Nelson City Council

Maitai Dam
Intermediate Dam Safety Review
2015

Tonkin & Taylor

May 2015

Photograph 5.3 - Broken winch.

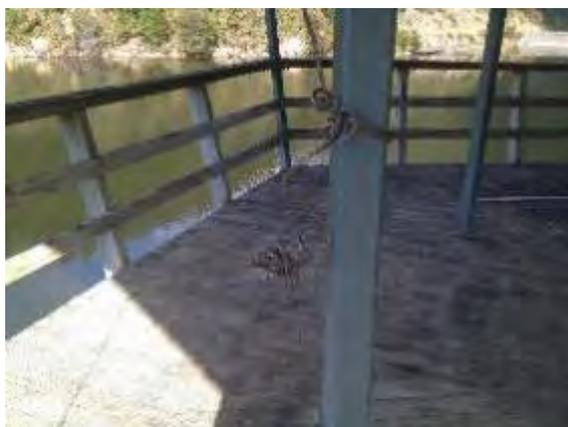
Screen and hoist condition continues to be addressed by regular inspection and replacement and recorded in the diver's inspection report (Photograph 5.3). It is understood that NCC have decided not to replace the screen winch. Draw down procedures, including during an emergency, should be reviewed to ensure that any operations involving screen removal or replacement are updated in the OM&S manual.

Photograph 6.16 – Hydraulic piezometer gauges P1 (left) to P6 (right).

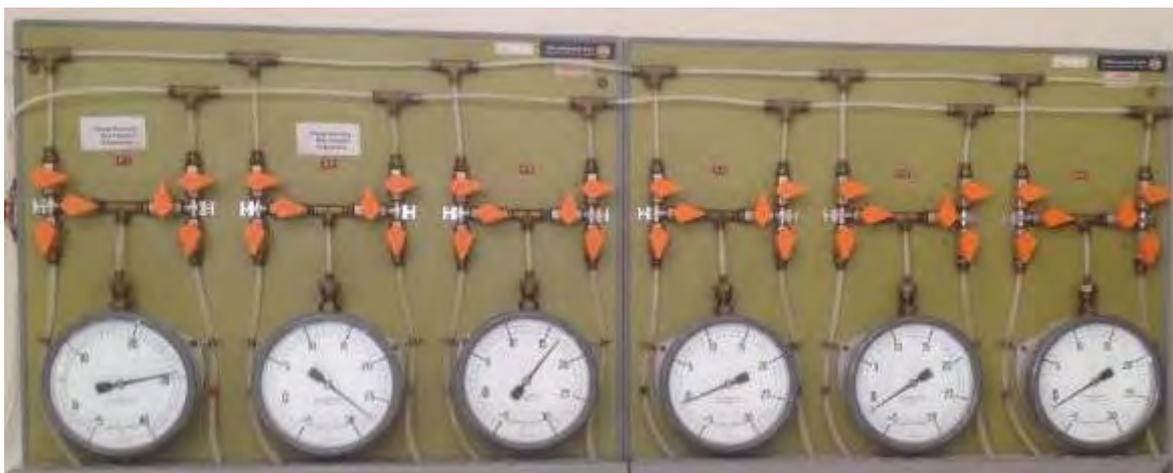
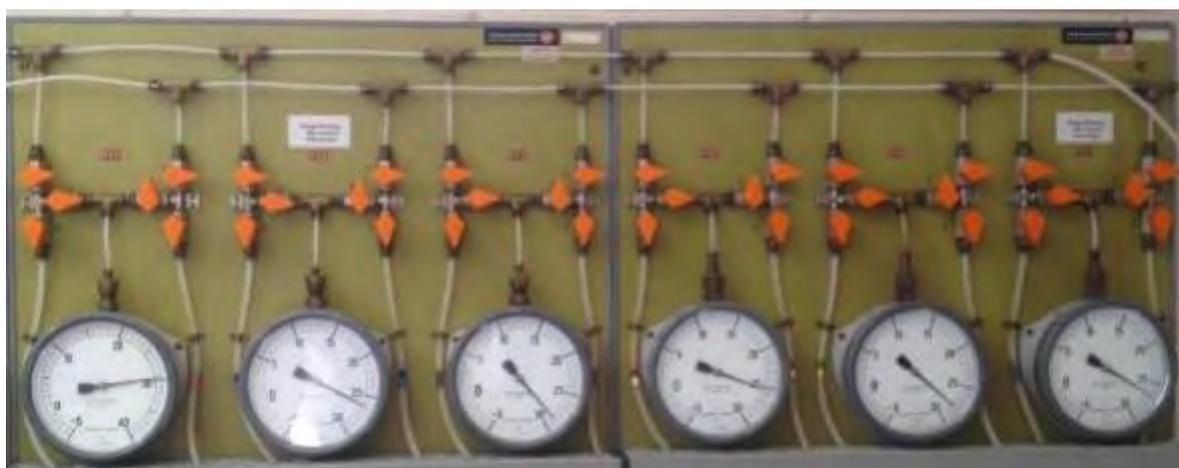
The room for the piezometer gauges is relatively dry. Photograph 6.16 to Photograph 6.20 shows the piezometer gauges at the time of inspection. The humidity in the room is limited by a cover over the collection chamber for the dam's basal drainage system.

New automated flow meters consisting of a metal plate v notch weir and ultrasonic level detector have been installed on the LHS and RHS abutment drains (Photograph 6.21 and Error! Reference source not found.) in the seepage collection well. The flow meters resolve the health and safety issue arising from previously carrying out these readings manually (the central collector drain flows are not measured in the seepage collection well but are measured via the total outflow from the seepage well at the downstream of the outlet pipe).

DSR 2015 - 8 Review and update OM&S manuals to ensure all flow measurement procedures are up to date.

PLOT 1 - INSTRUMENT LINE 1 (01 APRIL 2012 TO 31 MARCH 2015)

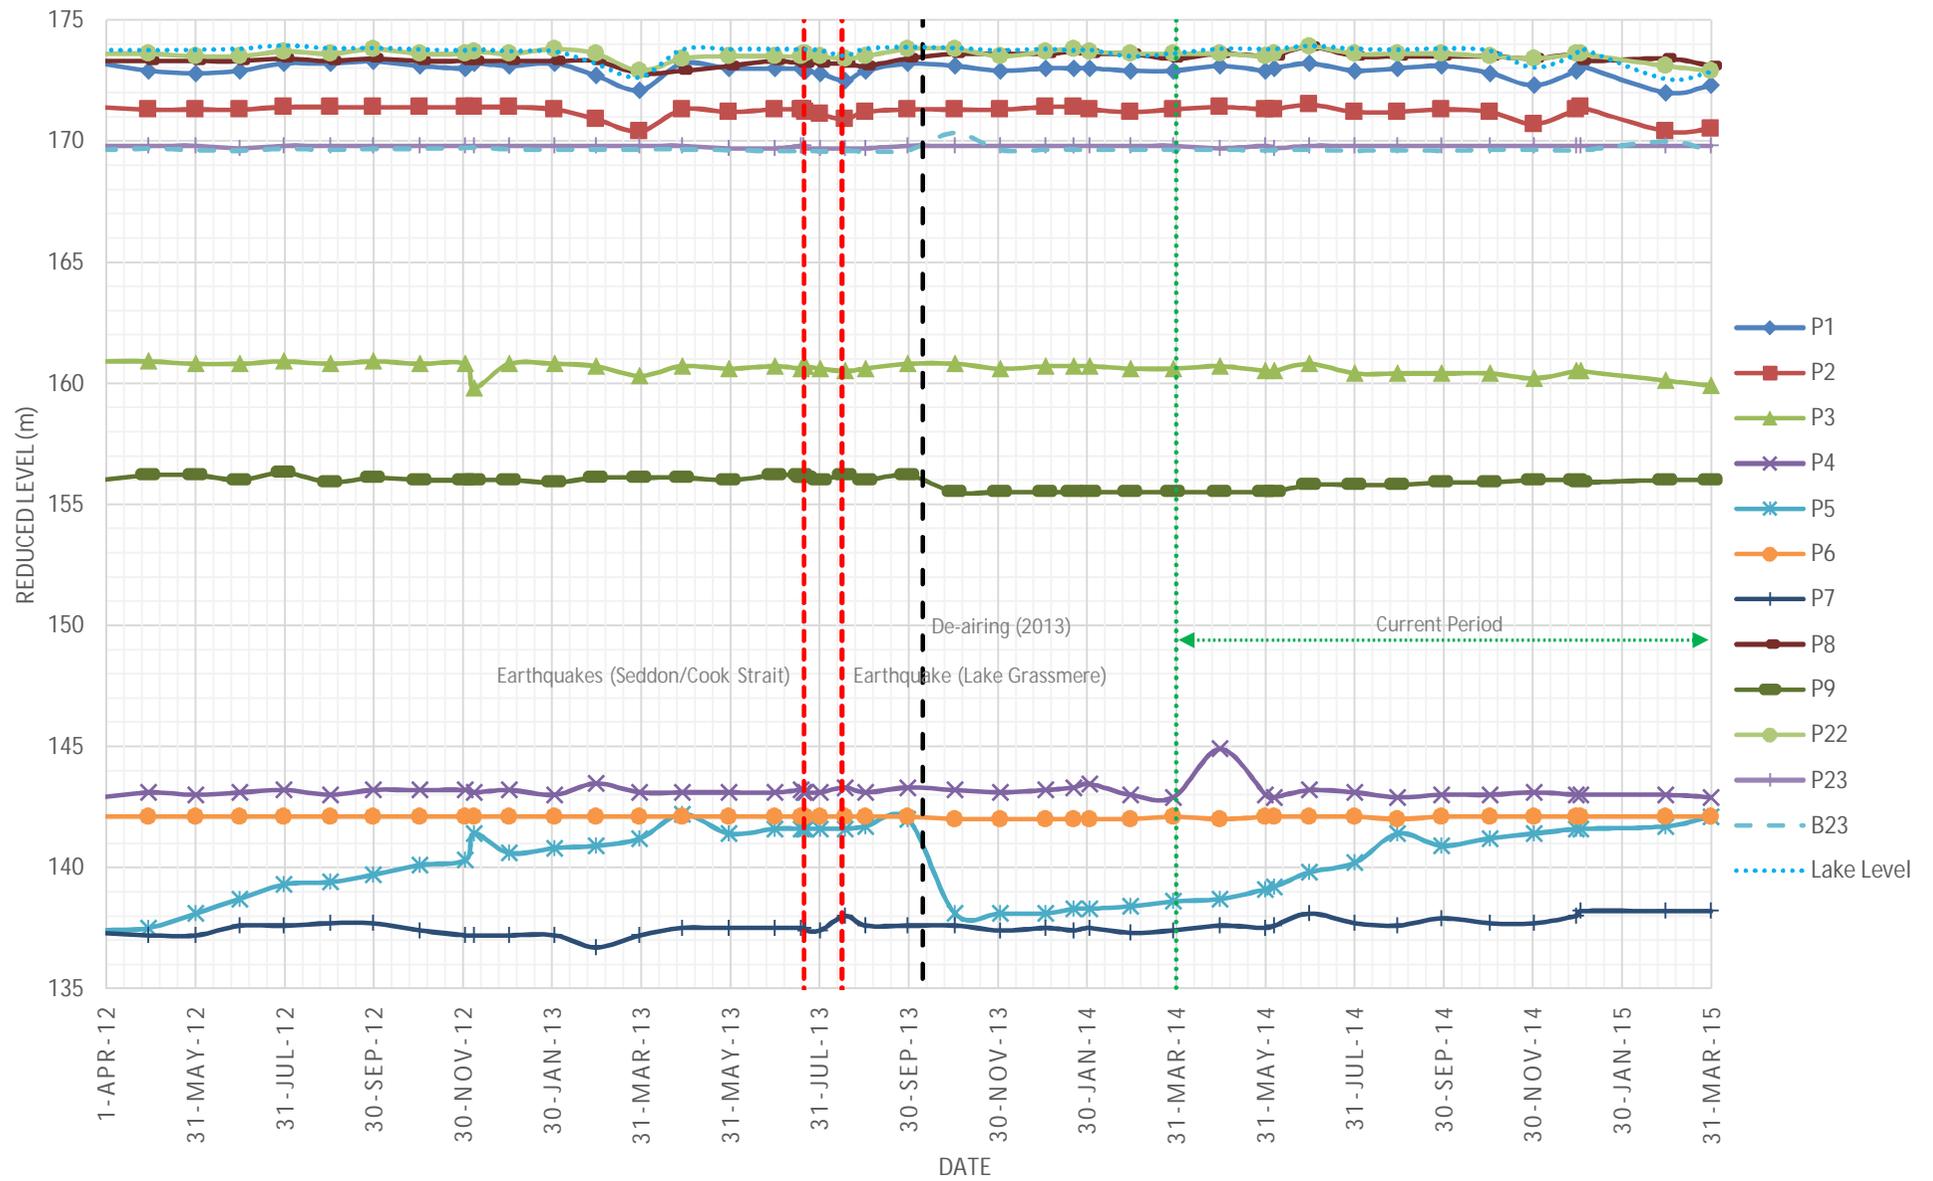
Instrument Line 1 (Plot 1, Appendix B)

- P1, P2 (upstream foundation piezometers) and P9 (downstream) continue to approximately mirror reservoir level.
- P4 (downstream) recorded its highest reading of RL 144.9 m (1.4 gauge reading) since the reservoir was filled in 1987 exceeding the trigger level of RL 143.5 m (0.0 gauge reading). The spike coincided with a high monthly rainfall of 357 mm. The readings have since returned to normal.
- P5 (downstream foundation piezometer) is continuing to trend upwards, with all readings since August 2014 exceeding the trigger level of RL 140.0 m (-3.5 gauge reading). P5 is known for its sensitivity to air (refer Piezometer limits comments in Appendix D). We also note that the original limit set in the Operations and Maintenance Manual was RL 147 m,

with the lowered limit of RL 140 m being adopted at a later stage based on data trends rather than direct safety concerns. Therefore, exceedance of this lower limit in isolation, is not, in itself, cause for alarm. It is noted that the de-airing undertaken in October 2013 resulted in an immediate response from P5 with a drop of piezometric level of approximately 4 m recorded. The trend confirms that this instrument is performing poorly and is unlikely to give reliable results. Further review should be undertaken as to whether this instrument should be more frequently deaired or if sufficient coverage is obtained from other instruments (Refer recommendation DSR2015-3 below)

- P7 (downstream foundation piezometer) exceeded the trigger level of RL 138 m (-5.5 gauge reading) by up to RL 0.2 m on four occasions during the monitoring period. No documentation was seen to demonstrate that any action was taken as a result of these trigger level exceedances. The readings are however within historical limits. While infrequent exceedances, in isolation, do not necessarily constitute a dam safety issue, they should continue to be monitored on a monthly basis to determine if action needs to be taken.

- P8 (upstream) recorded its highest reading of RL 173.9 m (30.4 gauge reading) since the reservoir was filled in 1987, however, this is below the trigger level of RL 174 m (30.5 gauge reading). The readings have subsequently reduced to more typical levels but should continue to be closely monitored in case the instrument starts to trend upwards more frequently to the trigger level.

- P23 (downstream) experienced a small spike on 01 June 2014 before returning to normal. Upon reviewing the surrounding data it is apparent that the most likely cause for this is incorrect entry of the data (28.3 m entered rather than 26.3 m). The data spike is unlikely to be a true piezometer reading and the data has been manually corrected to reflect this.

DSR 2015 - 3 Review P5 de-airing requirements and criticality.

PLOT 2 - INSTRUMENT LINE 2 (01 APRIL 2012 TO 31 MARCH 2015)

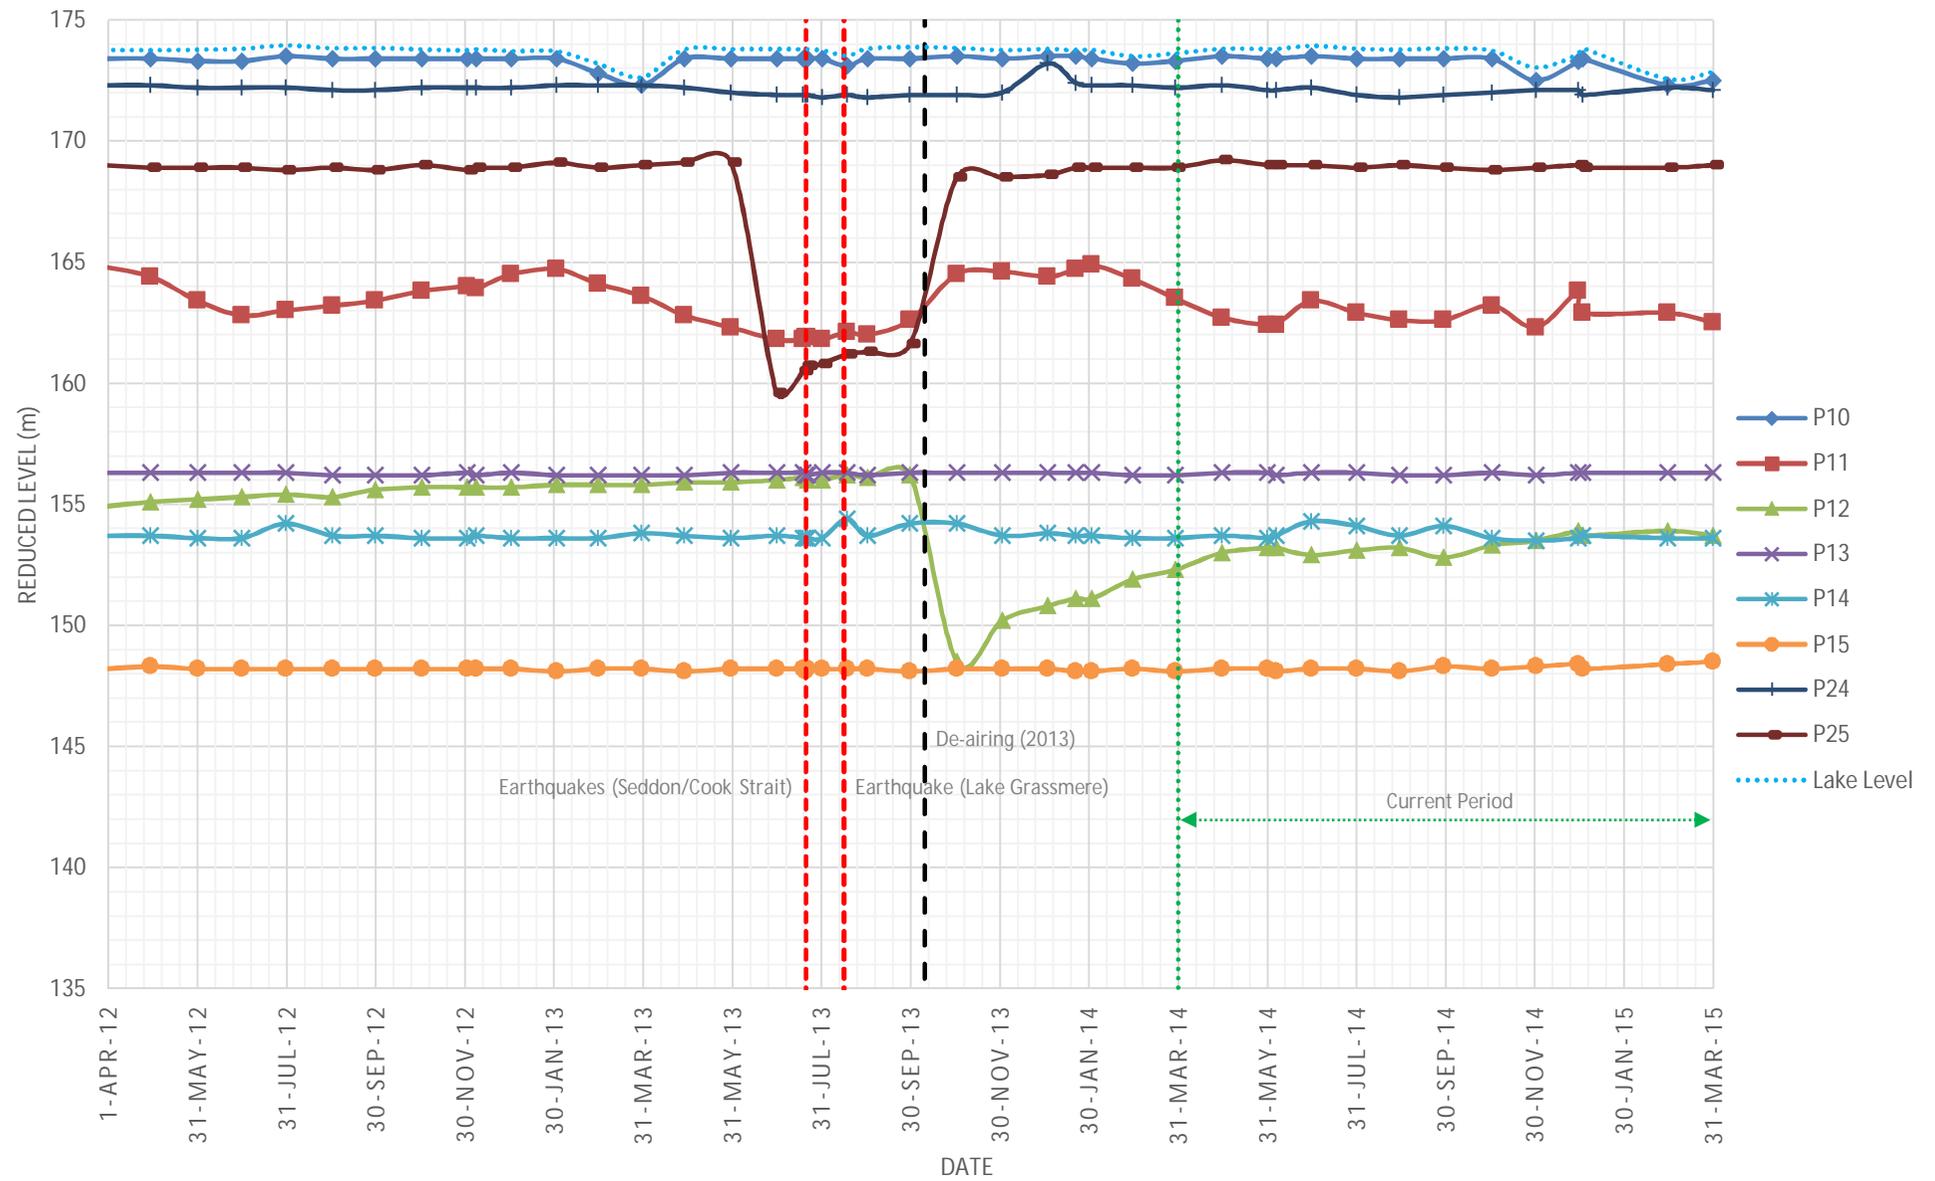
Instrument Line 2 (Plot 2, Appendix B)

- P10 (upstream foundation piezometer) continues to approximately mirror reservoir level.
- A data spike is evident in P11 (upstream foundation piezometer) on 01 June 2014, where an apparent reading 10 m greater than neighbouring readings was entered. Upon reviewing the surrounding data it is apparent that the most likely cause for this is incorrect entry of the data (28.9 m entered rather than 18.9 m). The data spike is not considered to be the true piezometer reading and the data has been manually corrected to reflect this.

- P12 (downstream foundation piezometer) continues to rise following de-airing in October 2013. The trend confirms that this instrument is performing poorly and is unlikely to give reliable results.

- P14 (downstream) appears to have been reasonably consistent over the past monitoring period with trigger level exceedances comparable to the last period. While these infrequent exceedances, in isolation, do not necessarily constitute a dam safety issue, they should continue to be monitored on a monthly basis to determine if action needs to be taken.

Given the repeated exceedances of trigger levels, we reiterate the recommendation to review the appropriateness of instrument trigger levels and update as required. This review should be undertaken after evaluation of potential failure modes, and piezometer assessments (CSR recommendation 2013-5, 11 and 12a).

PLOT 3 - INSTRUMENT LINE 3 (01 APRIL 2012 TO 31 MARCH 2015)

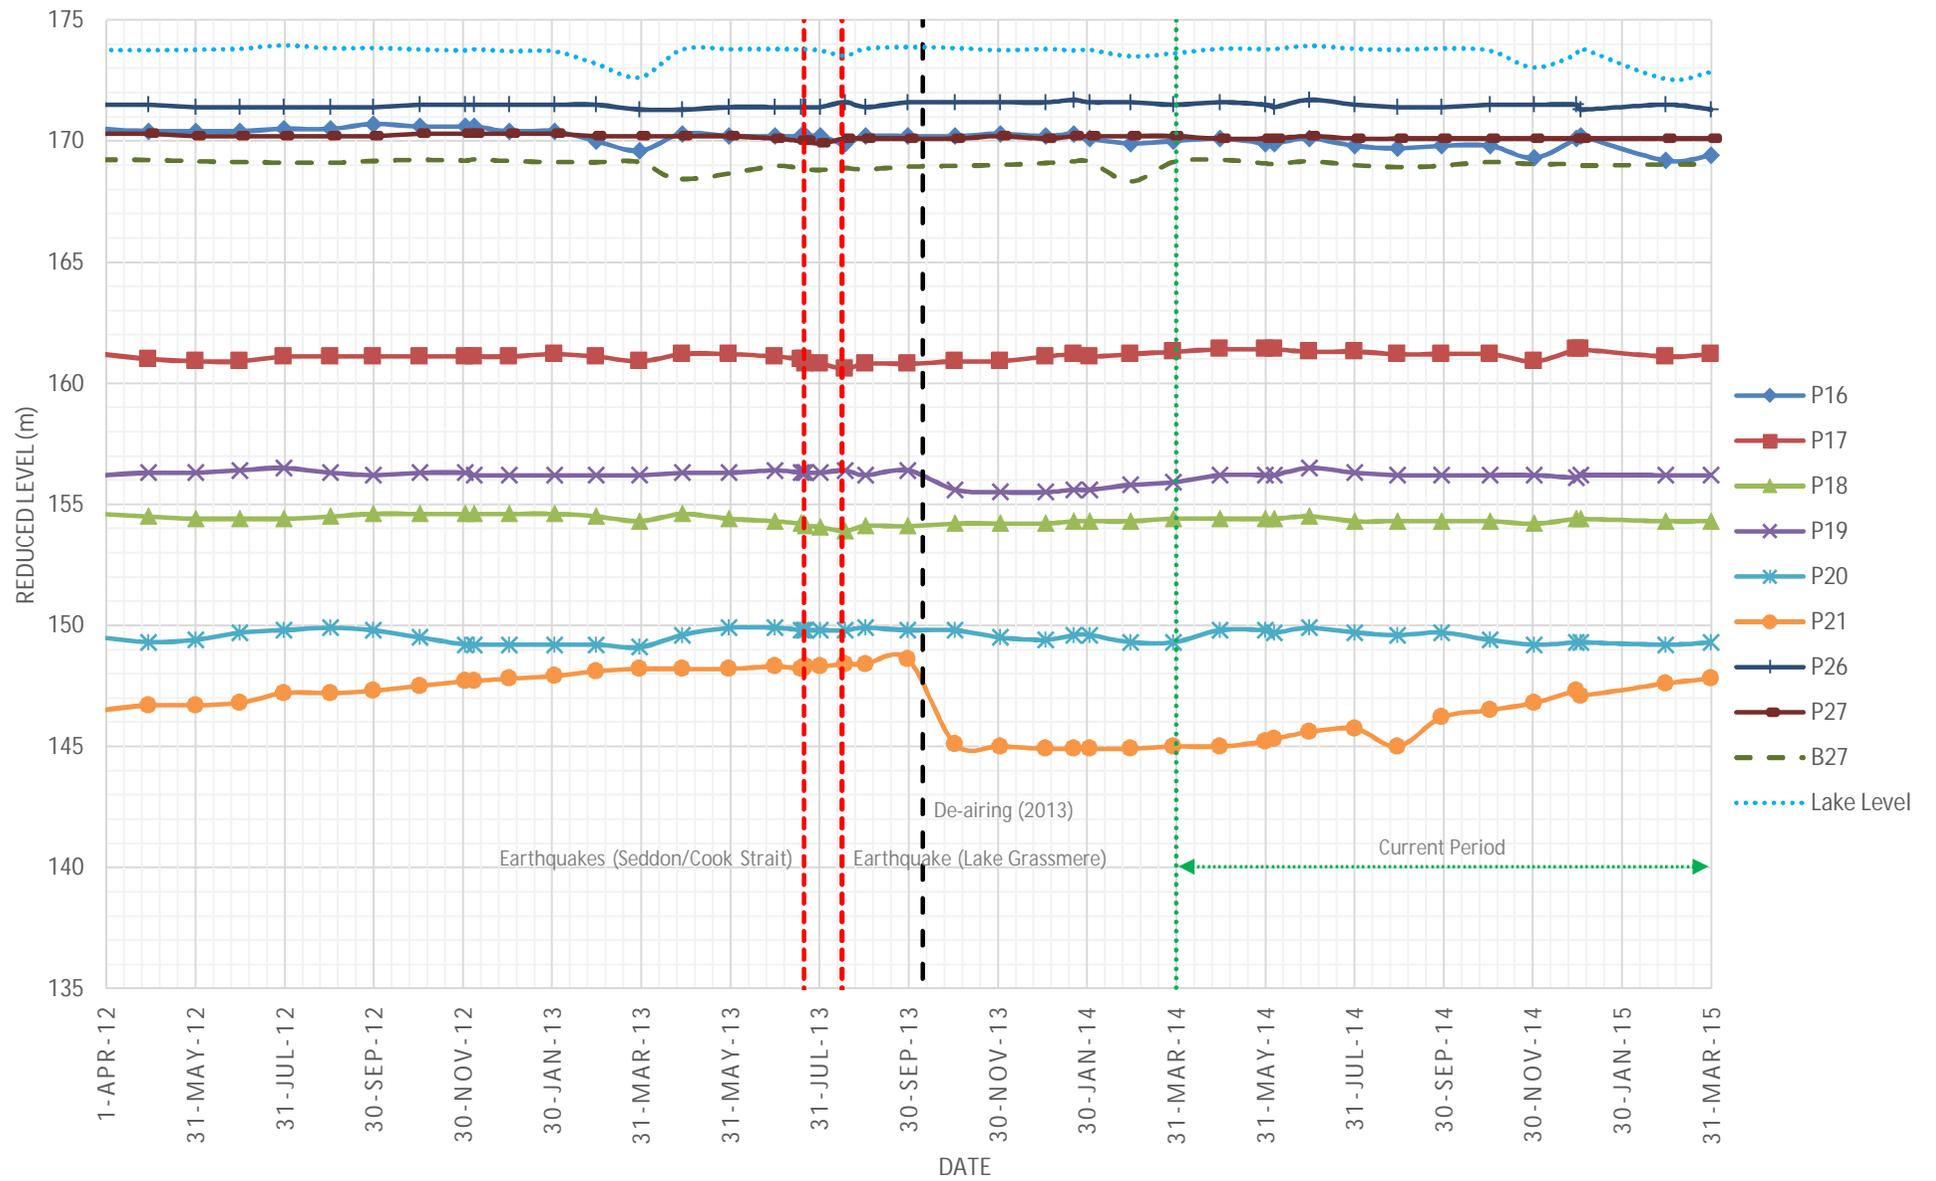
Instrument Line 3 (Plot 3, Appendix B)

- P16 (upstream foundation piezometer) and P20 (downstream) continue to approximately mirror reservoir level.
- P19 (downstream) recorded its highest reading of RL 156.5 m (30.0 gauge reading) since the reservoir was filled in 1987, however, this is below the trigger level of RL 156.8 m (30.3 gauge reading).
- As expected the de-airing of P21 (downstream foundation piezometer) has only had a short term impact and readings have increased steadily over most of the monitoring period.

- P27 (downstream) appears to have been reasonably consistent with a range of only 100 mm during the last period (RL 170.1 to 170.2 m). However, the current trigger limit is RL 170.2 m (26.0 gauge reading), so even this small deviation from normal has resulted in trigger level exceedance. As noted below, we recommend review of trigger levels to more accurately reflect data trends and design limits.
